Revisions	
Project	
BEDFORD PASSAGE DEVELOPMENT	
Client	
MIDDLESEX ANNEXE LLP	
Title	
HARD LANDSCAPE DETAILS - SHEET 01

Drawing No. **BPD-HLM-00-XX-DR-L-30401** Revision **C13**

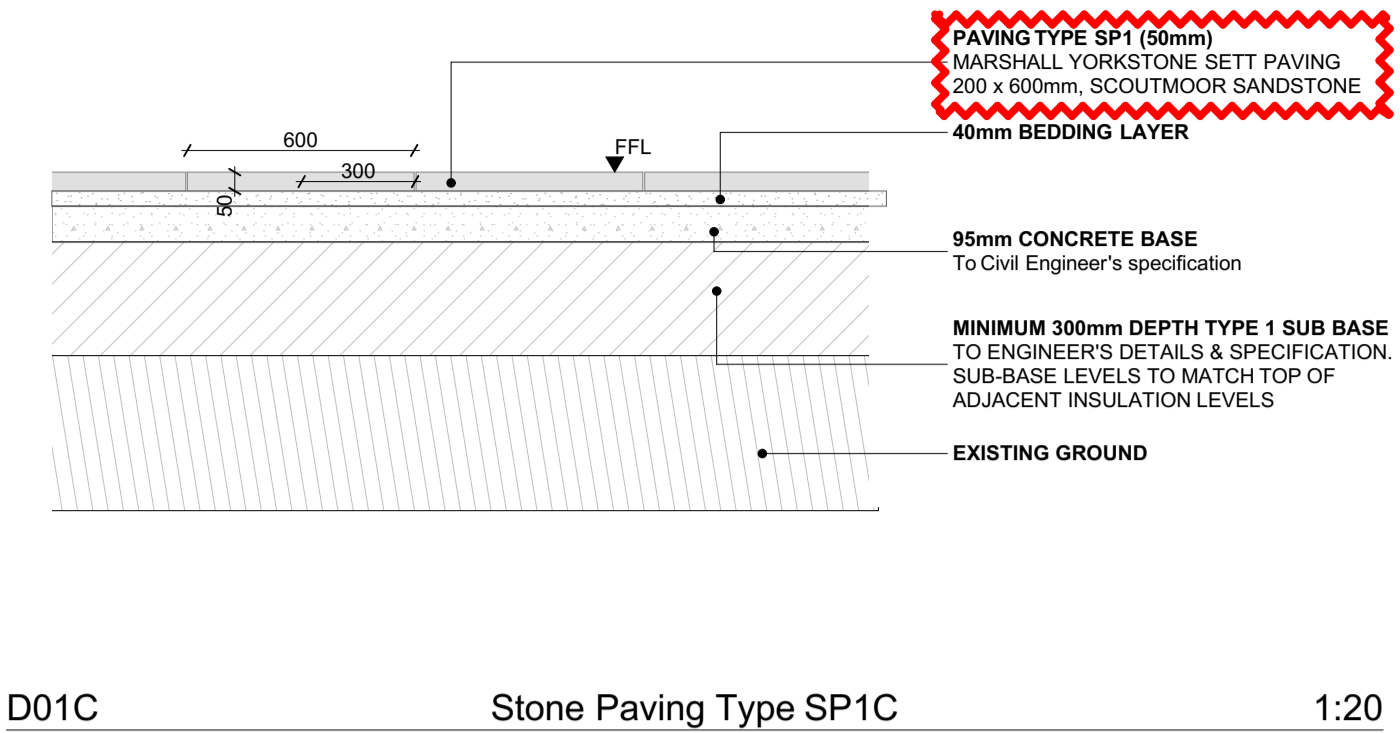
PAVING DETAILS UPDATED
- VCL LAYER ADDED

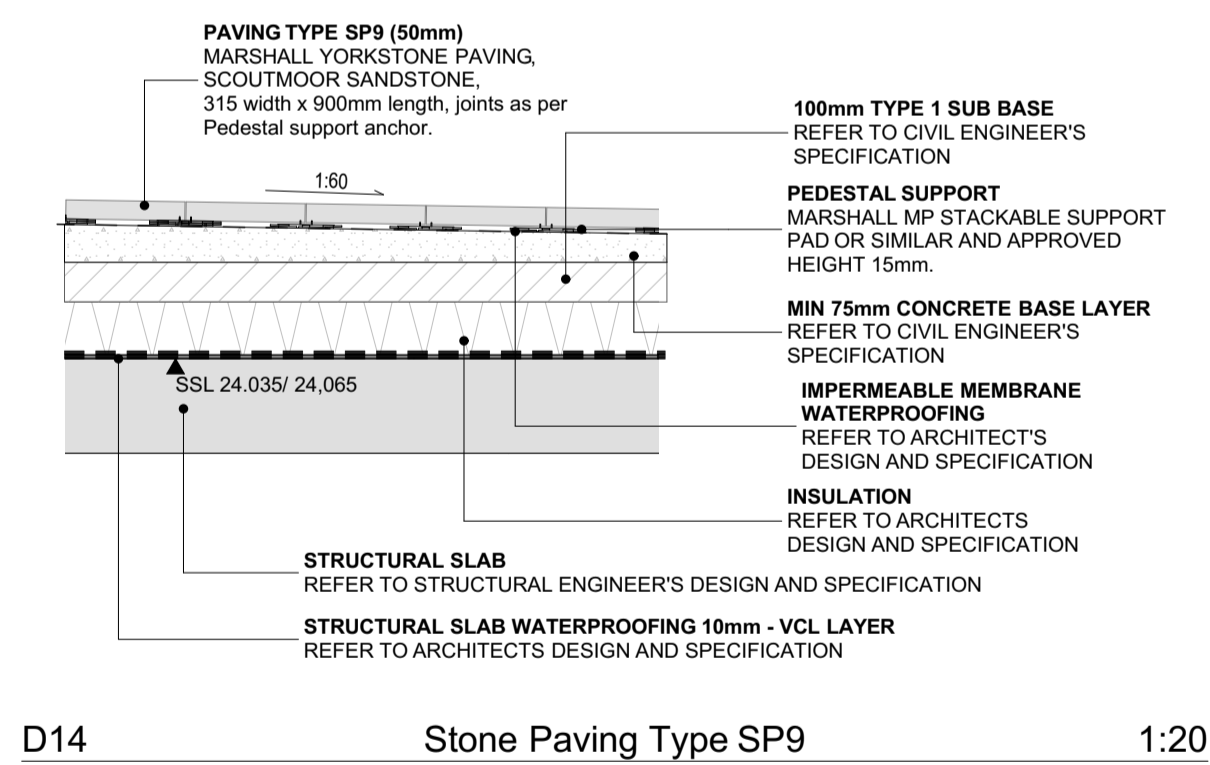
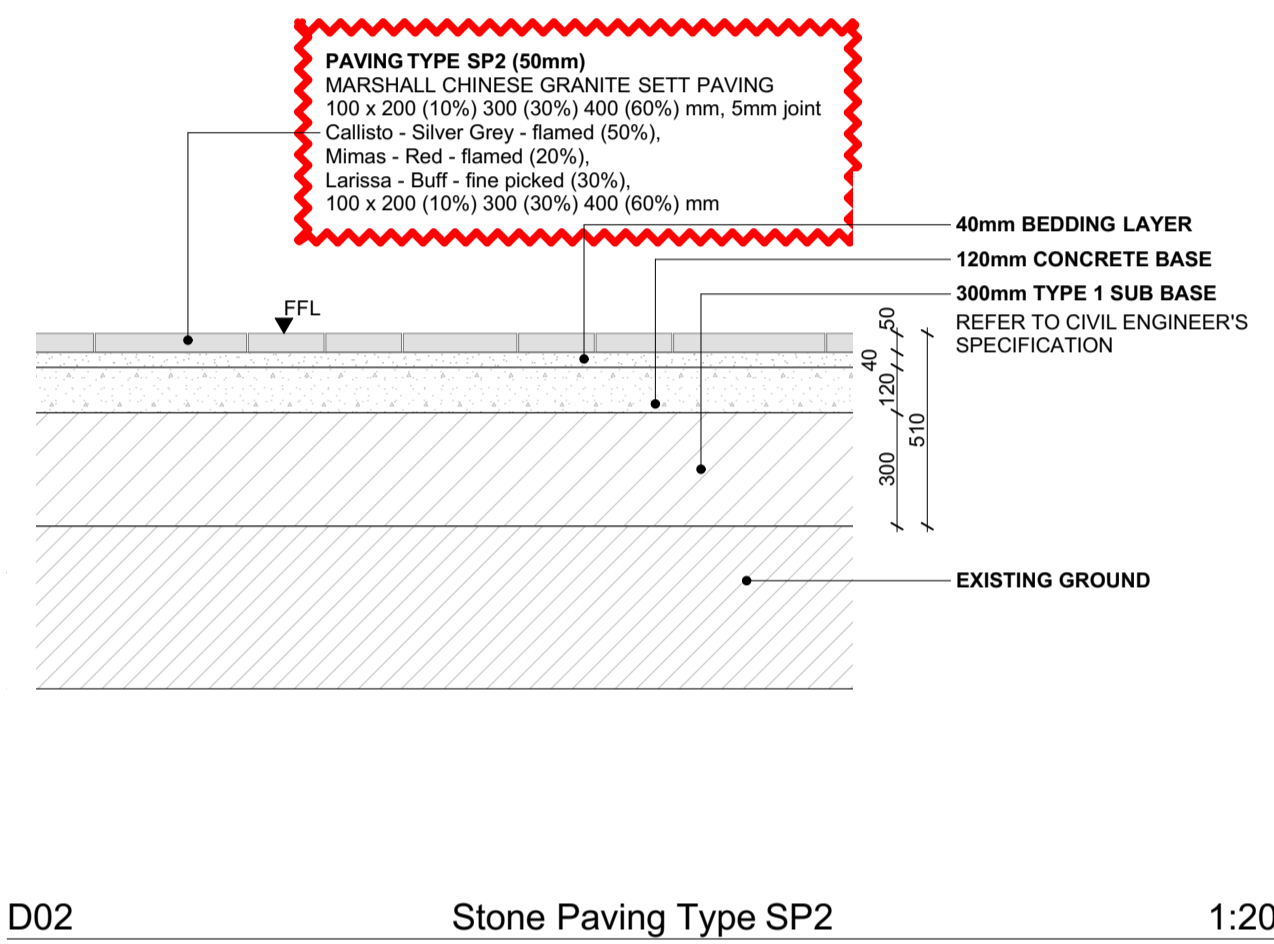
PAVING DETAILS UPDATED
- VCL LAYER ADDED

PAVING DETAILS UPDATED
- VCL LAYER ADDED
